0.0 Planning Application PLN20/0146 at 530-532 Doncaster Road Doncaster, for the use and development of the land for a five-storey mixed use building comprising 22 dwellings, a medical centre and the creation and alteration of access to a road in a Road Zone, Category 1.

File Number:	IN20/597
Responsible Director:	Director City Planning and Community
Applicant:	532 Doncaster Road Unit Trust
Planning Controls:	Residential Growth Zone – Schedule 2 (RGZ2), Design & Development Overlay –Schedule 8 (DD08-1), Principal Public Transport Network (PPTN area)
Ward:	Tullamore
Attachments:	1 Legislative Requirements 2 Decision Plans 3 Locality Map 4 Objector Map

Figure 6: North elevation (Doncaster Road elevation)

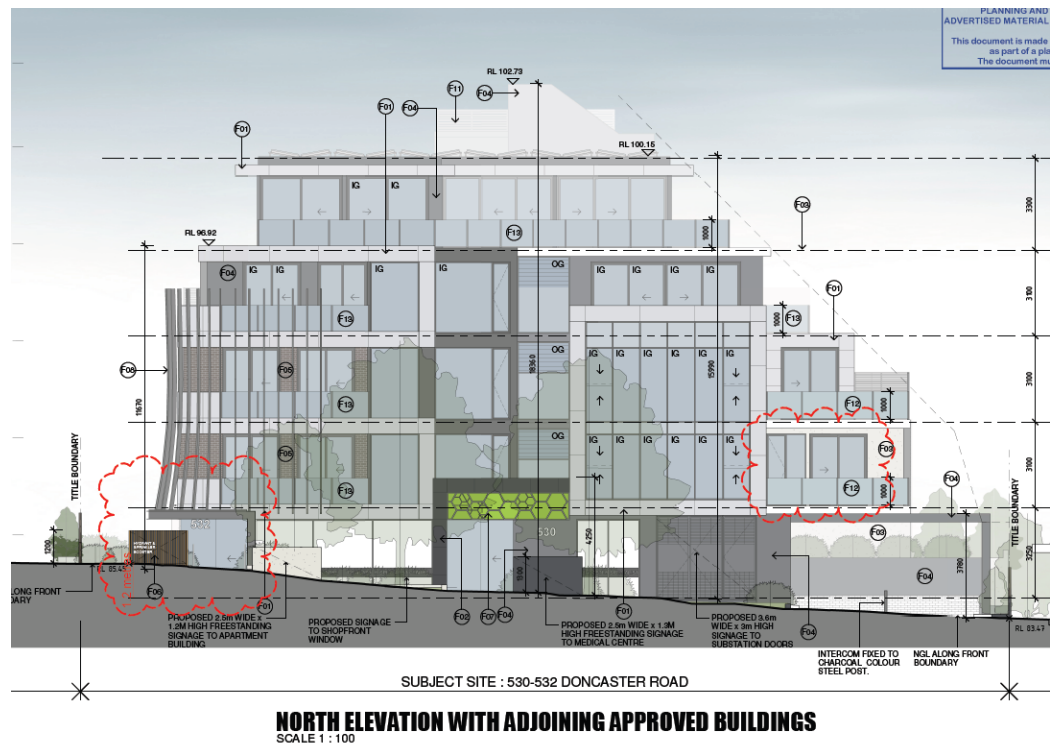
- 7.15 The maximum height of the building is 16.66 not including rooftop services (the height to the rooftop services is 18.99 metres).

- 7.16 The proposal therefore seeks dispensation for its 16.66 metre height under the DDO8 (10 metre requirement) and the RGZ (14.5 metre requirement).

- 7.17 The maximum building height requirements are not mandatory and therefore can be varied with planning permission. This discretion provides flexibility to achieve design excellence to the built form and to appropriately respond to the site context within the Main Road Sub-Precinct, where additional height could be considered acceptable.

Figure 7: Streetscape elevation of approved buildings adjacent to the proposal

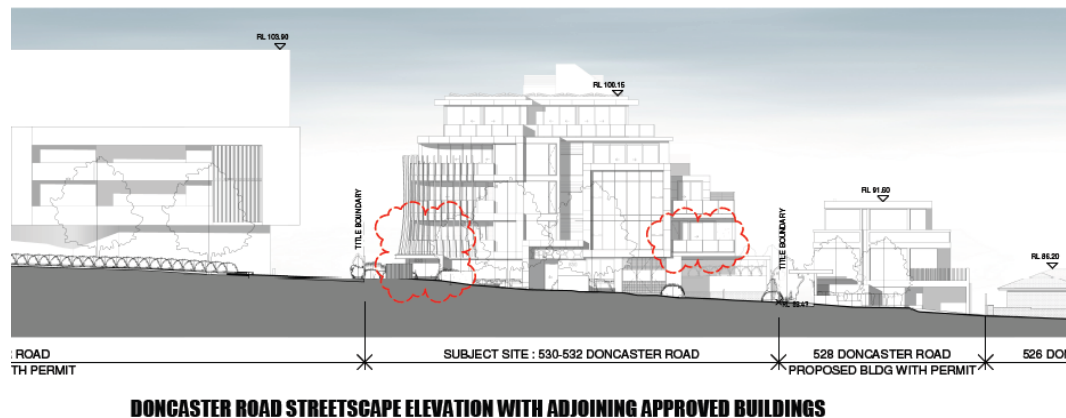
- 7.20 Within this context, the proposed five-storey built form will sit comfortably within this specific section of the streetscape, as it provides a transition between the more intensive eight-storey built form within the ACZ to the east and the medium density three-storey scale to the west.

Figure 12: Vertical shadow diagram (Section C-C)

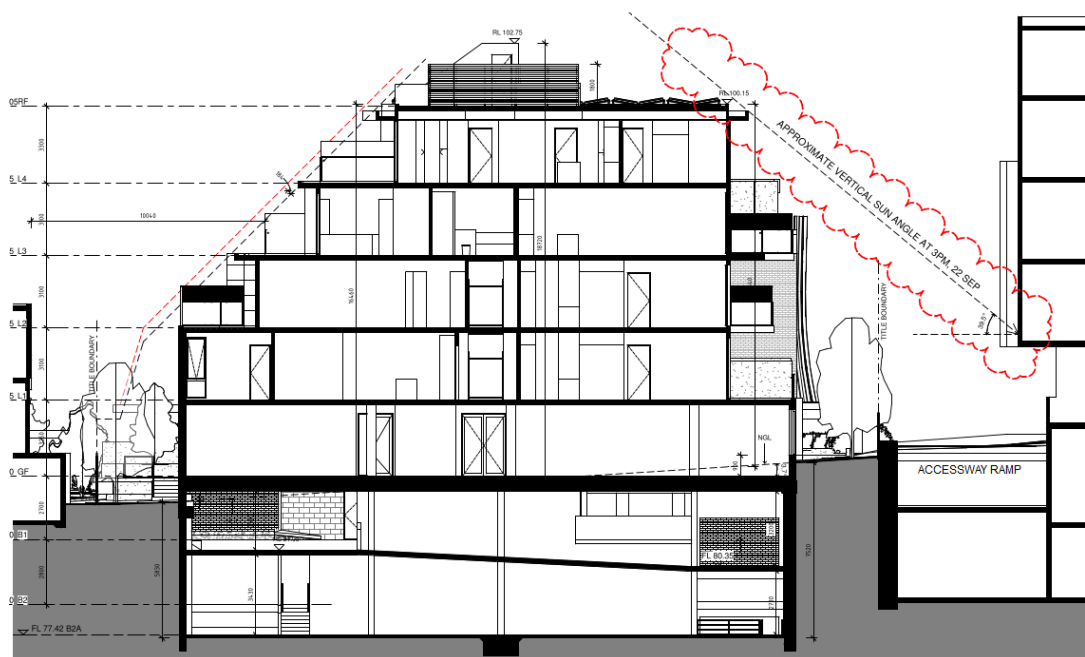
- 7.51 The proposal will inevitably cast shadows into the adjoining properties at different times during the day, including to the approved aged care facility within the adjoining property to the east.
- 7.52 To the south and west, the stepped built form and increased setbacks of the development will minimise the extent of overshadowing to the adjoining properties.
